## REQUEST FOR PROJECT REVIEW

Add - Bridport STP MM21(4)

Scoping Report – Draft  
Middle Road Over East Branch Dead Creek  
Middle Road Culvert Replacement  
Bridport, VT

Town of Bridport  
Bridport, Vermont

#### 2.3 Description of the Area of Potential Effects (APE)

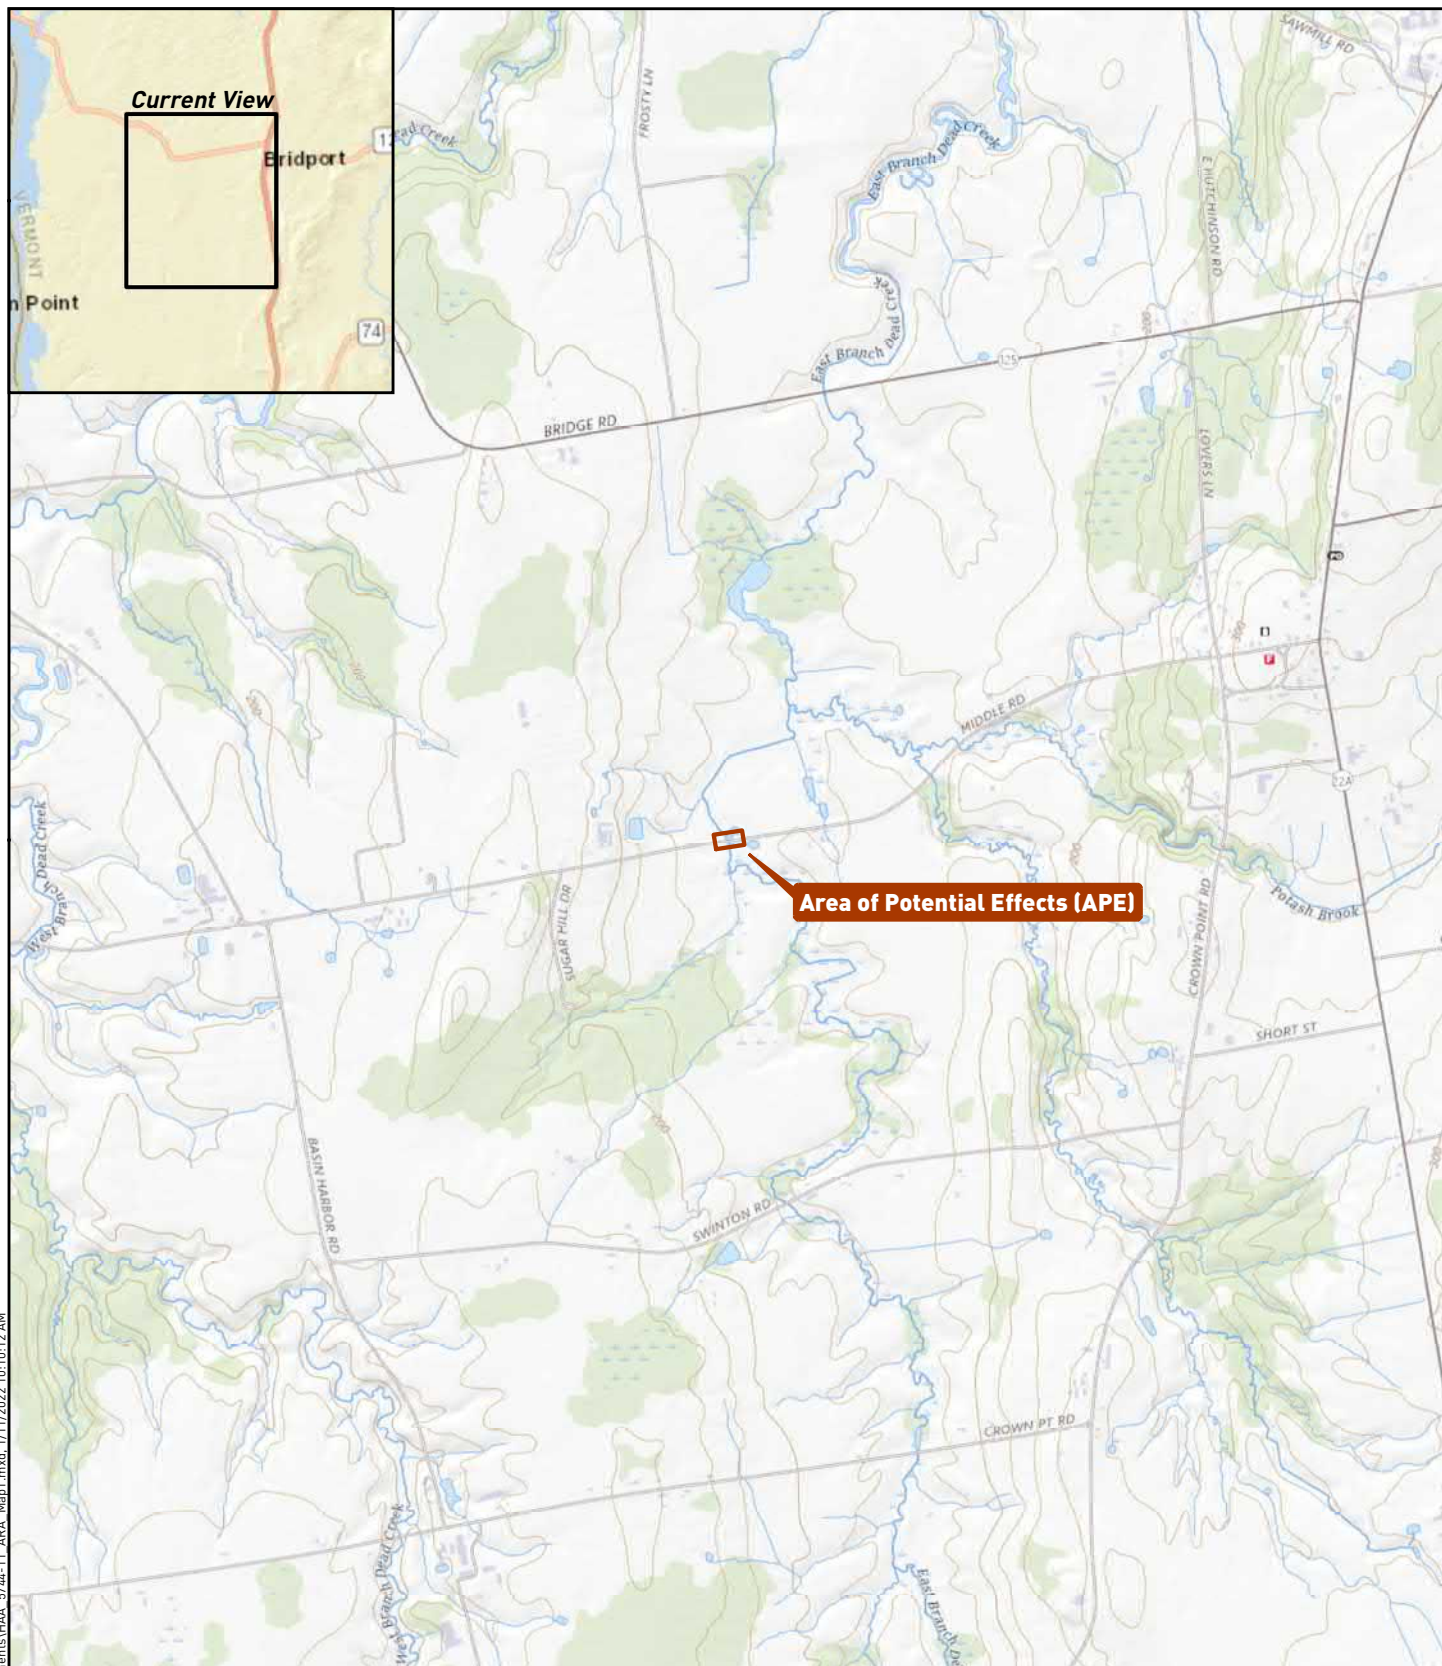
0.3?
